From: Christopher Byrum <chris.byrum1037@yahoo.com>
Sent: Tuesday, November 9, 2021 9:17 AM
To: Berkholz, Aaron; Murphy, Nate
Subject: C. Byrum summary memo - Grove Rd second opinion
Attachments: Grove Rd Creep - Byrum Sketches.pdf

Hello Aaron and Nate – This email summarizes my data analysis and evaluation of the creeping river bank slope and sheet pile wall on Grove Road near Ypsilanti, Michigan. In general, I understand the creeping slope had damaged the previous edge of roadway and storm outlet utilities in this area. A design team was hired a few years ago to develop a solution to the problem. a large steel sheet pile wall was installed on the river side of the roadway in the creep area in attempt to stop the ongoing creep movements of the roadway and sidewalk. I understand creep deformations have continued and the top of the new sheet pile wall has now moved outward by about 3-4 inches and slope slough creep is continuing to occur. The active wedge of soil retained by the wall has shifted and is starting to extend into the recently repaired roadway, causing settlements and cracking of the paved lane and curb line. A newer watermain exists under the sidewalk that is settling

Approximate nature of the slip zone near center of mass

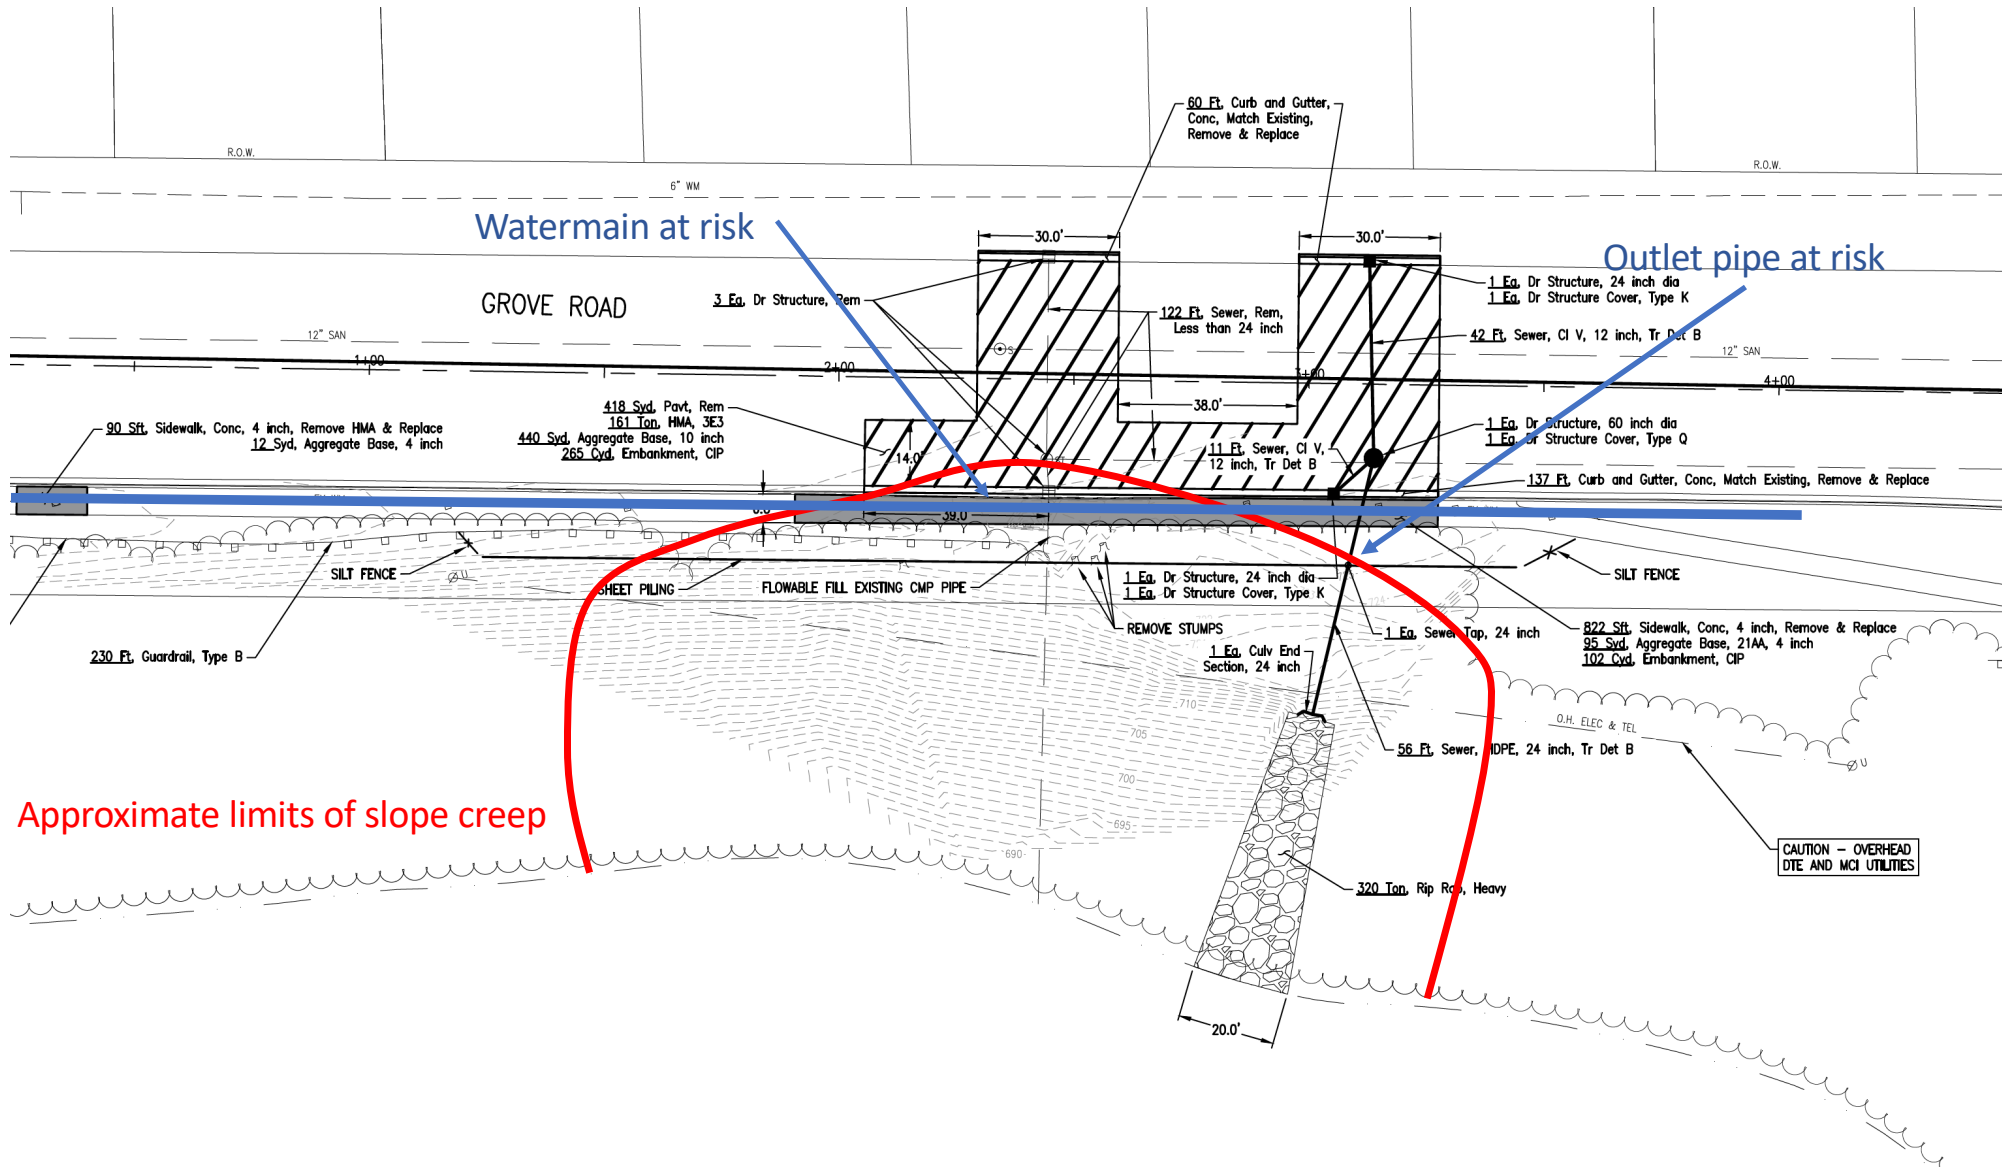
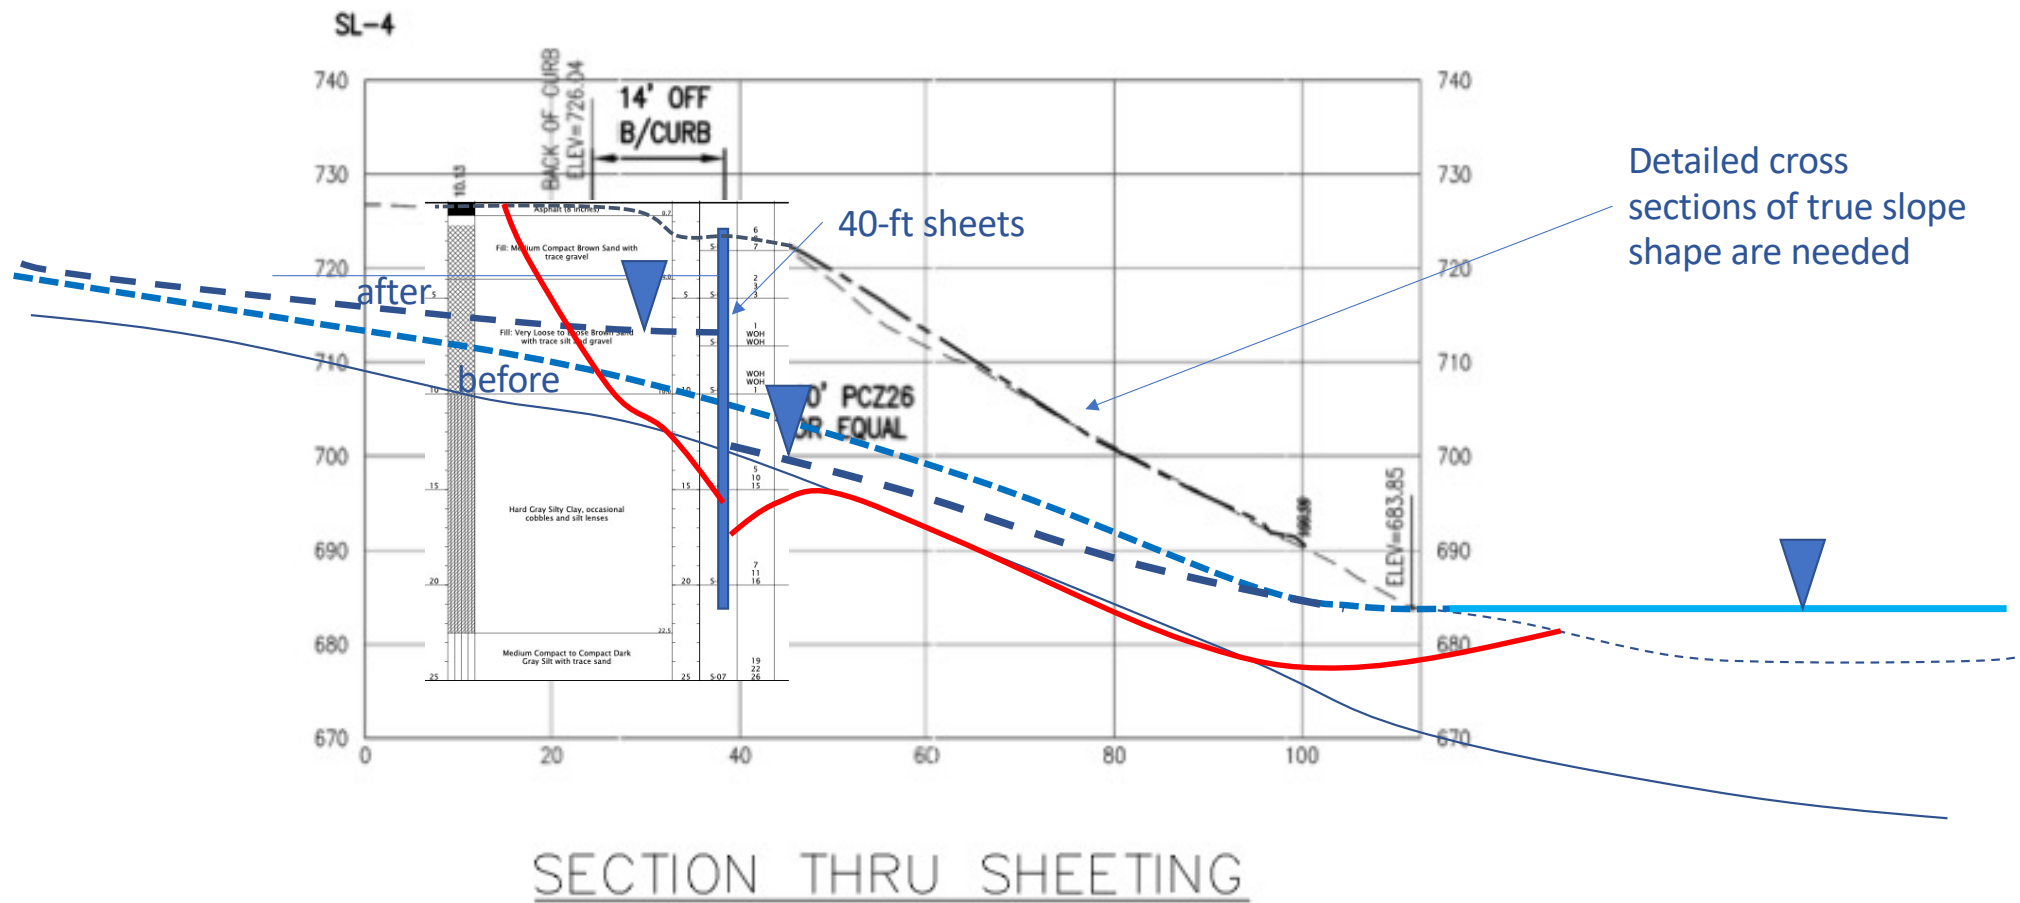
I have attached a pdf file containing my generalized interpretation of the limits and nature of the slope creep zone. Some recommendations we discussed are as follows:

1. Obtain detailed slope cross section information in the critical area. Extend the cross sections into the river so the global stability modeling can accurately simulate the existing slope angles and shapes.
2. Take action to turn off the critical watermain now before they start piling snow on it.
3. Investigate what it will take for WCRC to clear and grub and then establish 1:2 or flatter slopes in front of the existing sheeting.
4. Investigate two general “repair of the repair” options. Option one would be to use a ground anchor system installed through the existing sheeting and using a whaler and anchor head type detail along the front of the wall. Option two would be to use a combination of lightweight fills and geogrid/geotextile reinforcements behind the wall without using a ground anchor system.
